Standards Committee

Meeting Agenda

Wednesday, July 5, 2023, at 9:00am

TITLE	Champion
<p>2nd time to Committee. Discussed in May.</p> <p>Twenty (20) proposed drawings and revisions to WVDOH Standard details Book – Volume 2. The sheets are listed below. A summary of each sheet’s revisions are included in the meeting packet; and proposed sheets have revised areas highlighted yellow.</p> <ul style="list-style-type: none"> a) <i>TE1-3A Roadside Sign Supports Steel Beam Type</i> b) <i>TE1-3B Roadside Sign Supports Steel Beam Type</i> c) <i>TE1-3C Roadside Sign Supports Steel Beam Type</i> d) <i>TE2-1A Bridge or Retaining Wall Sign Mounting, Type K 1 & 2 Supports</i> e) <i>TE2-1B Bridge or Retaining Wall Sign Mounting, Type K 1 & 2 Supports</i> f) <i>TE2-2 Bridge or Retaining Wall Sign Mounting, Type L Pipe Post Mount</i> g) <i>TE2-3 Barrier Wall Sign Support Bracket Type D</i> h) <i>TE3-1 Overhead Sign Support – Steel Two Tube Span (TTS)</i> i) <i>TE3-2 Overhead Sign Support – Steel One Tube Span (OTS)</i> j) <i>TE4-3A Overhead Sign Support – Steel Double Arm Cantilever</i> k) <i>TE4-3B Overhead Sign Support – Butterfly Cantilever</i> l) <i>TE4-4A Overhead Sign Support – Single Arm Ca

STANDARD SHEET TE4-5

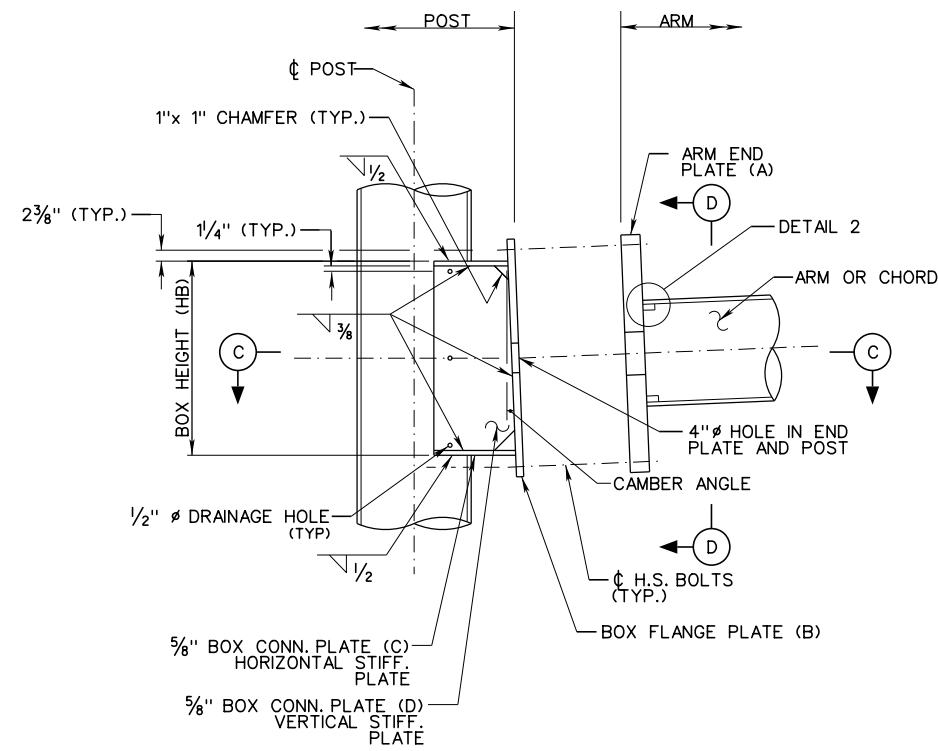
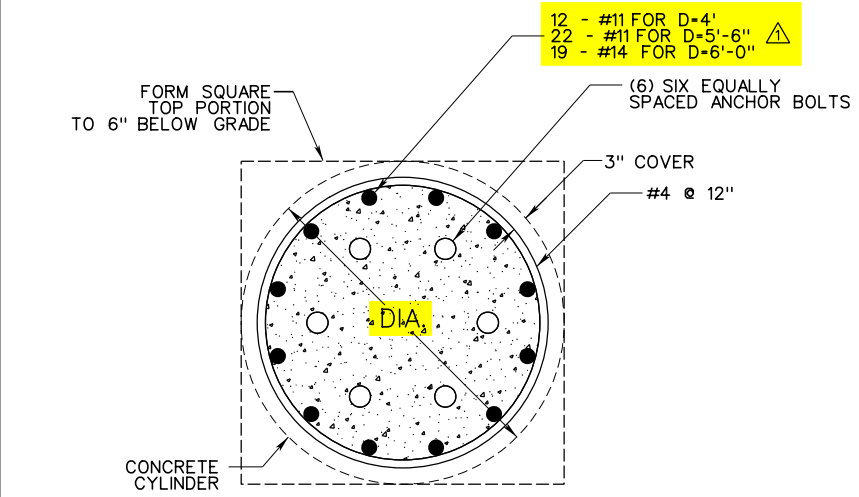
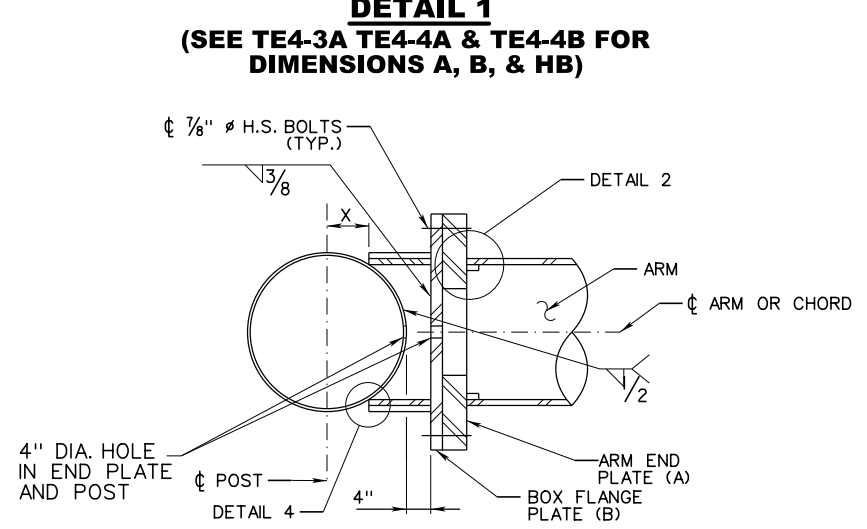
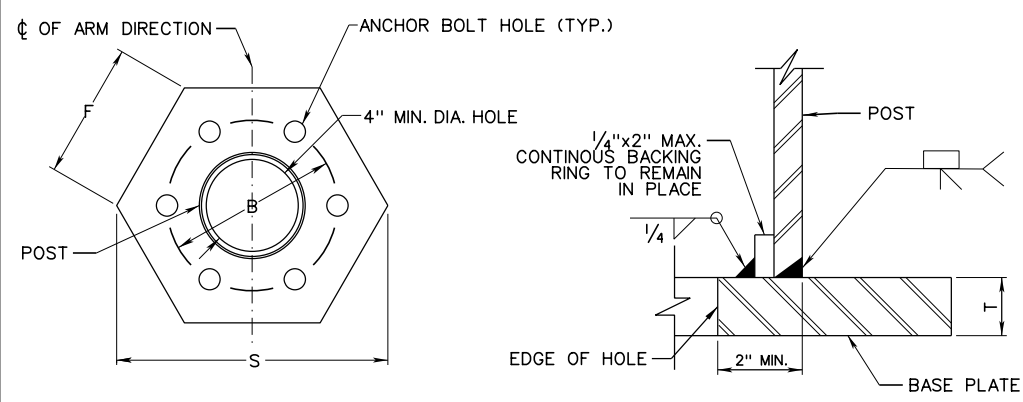
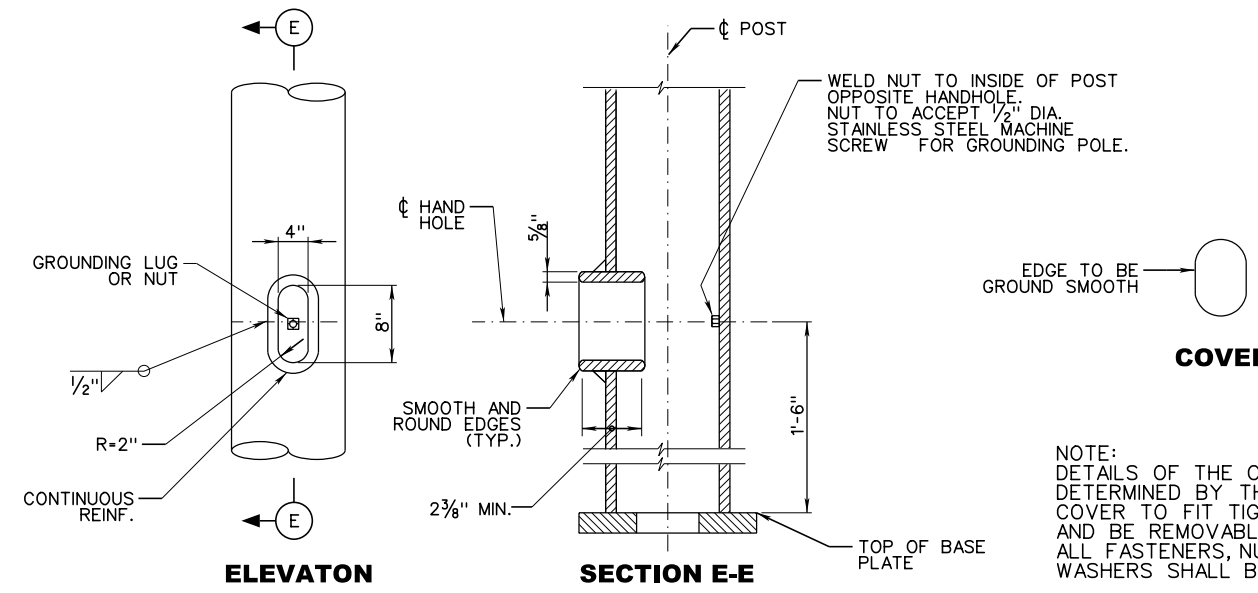
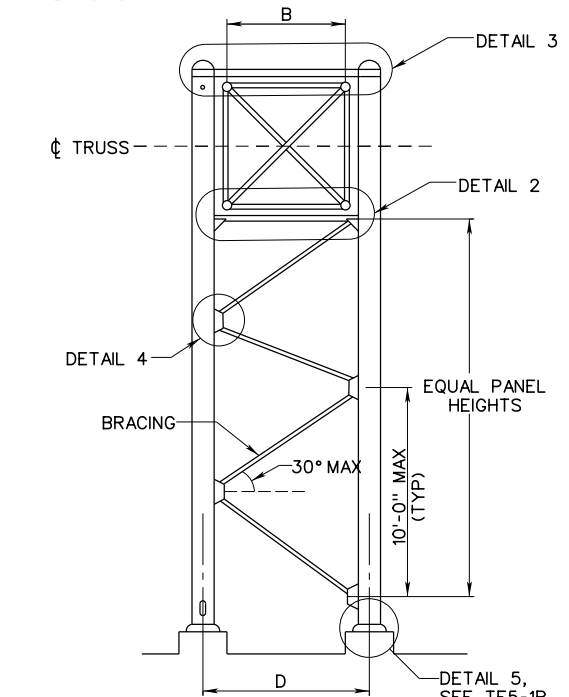
TE4-5	1	11/18/2022	Revised reinforcing based on footing size changes on TE4-4A.
TE5-1A	1	12/19/2022	Added camber information. Revised max span section length.
	2	2/22/2023	Revised chord member sizes. Deleted inappropriate weld.
TE5-1B	1	2/28/2022	Revised foundation reinforcement. Added Detail 8 to clarify reinforcing. Revised/Added bolt projection information. Clarified footing depth/embedment depth on Foundation Detail.
	2	12/19/2022	Updated Chord Splice Table to match changes made to TE5-1A. Deleted 8" post from Base Plate Table.
TE9-1	1	4/2022	Added saddle to all U-bolt connections on Type 2 and Type 3 details. Added Note 8 about including a saddle between the tube and the zee bar.
TEL-41	1	4/2022	Added note 5 to clarify requirements for size and number of hubs.
TES-31	1	3/2020	Revised sign number for pedestrian push buttons.
TEM-2 (2 of 2)	1	4/2022	Specified in notes 7 & 8 that markings that are to be used for turn movements in the middle of the intersection are to be Type V.

STANDARD SHEET TE9-1

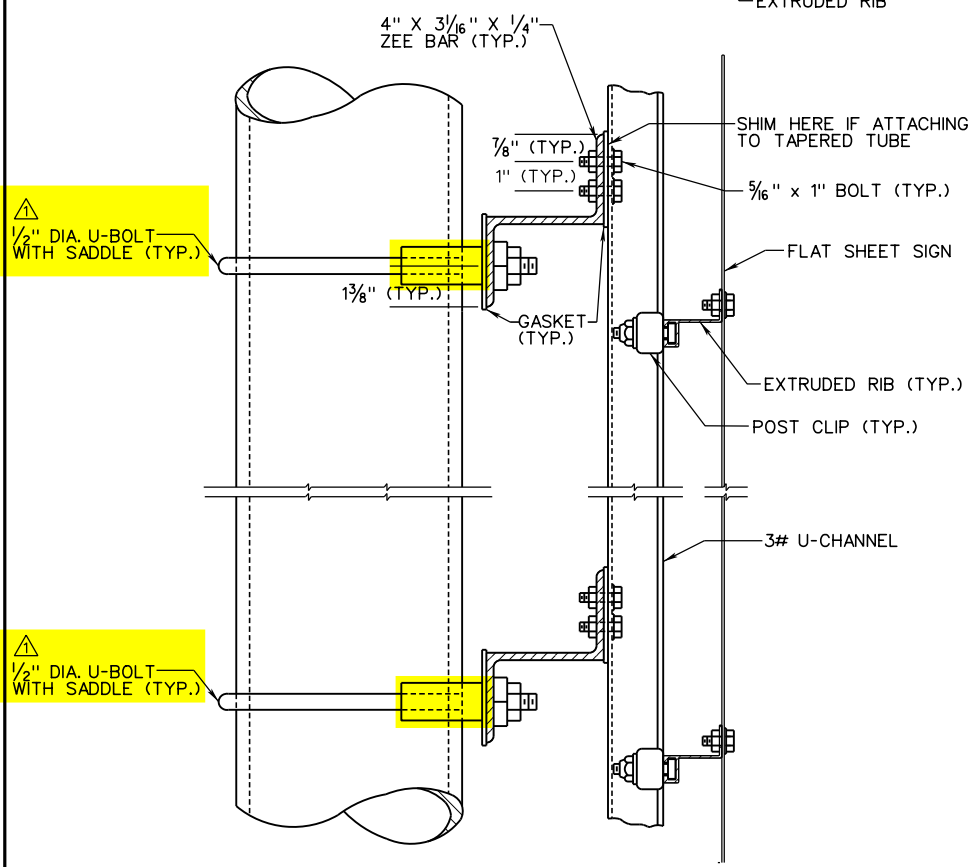
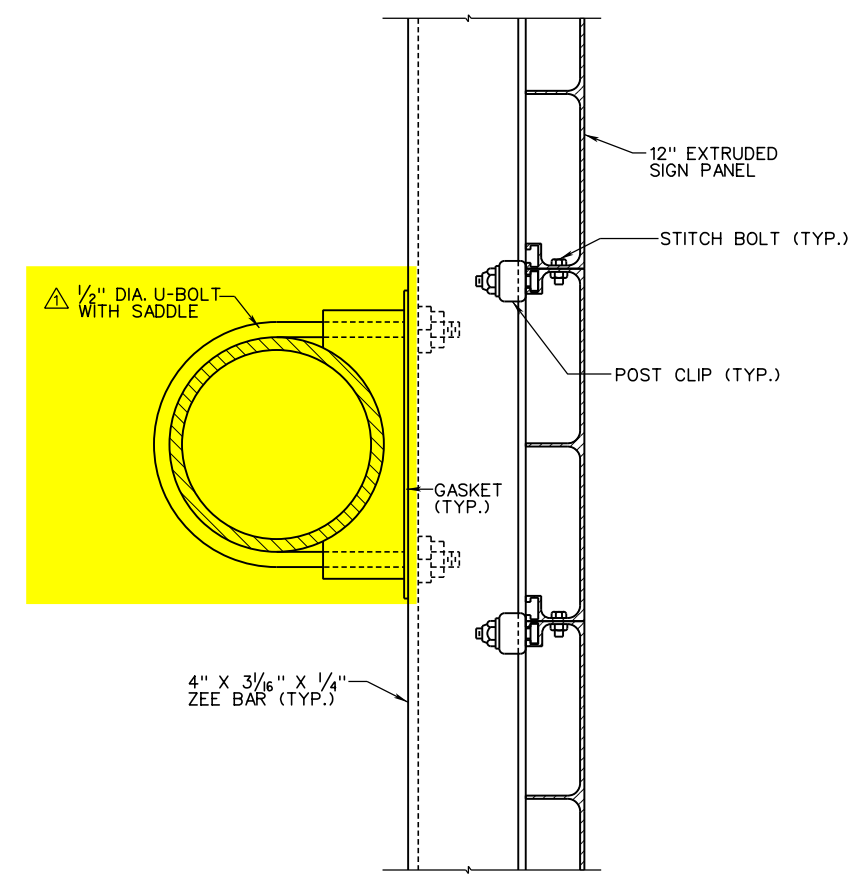
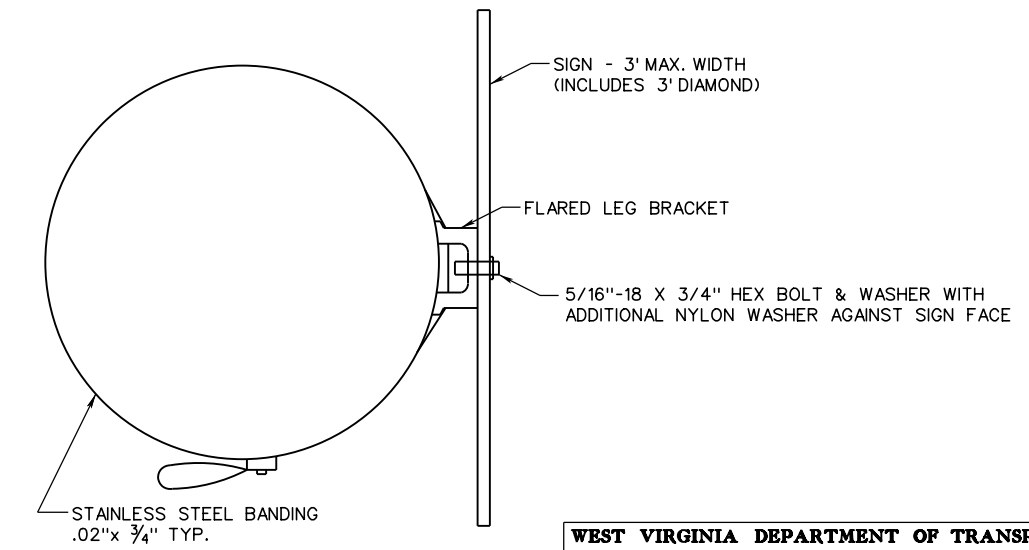
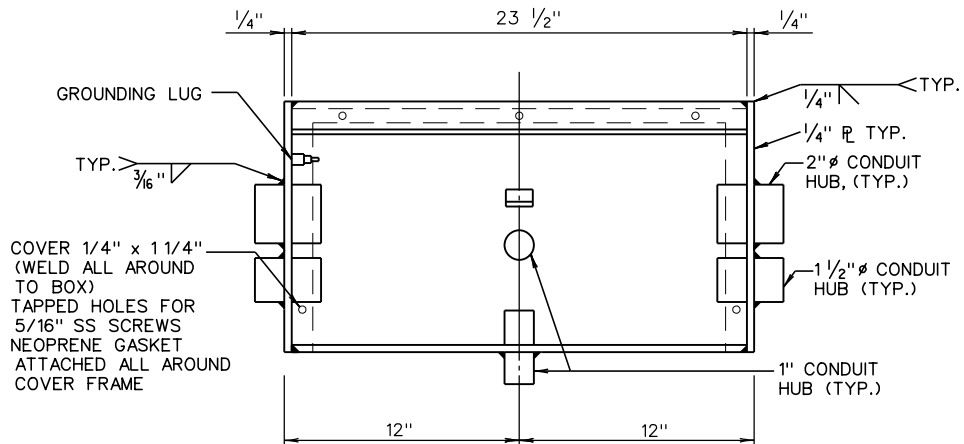
ADDED SADDLE TO U-BOLTS
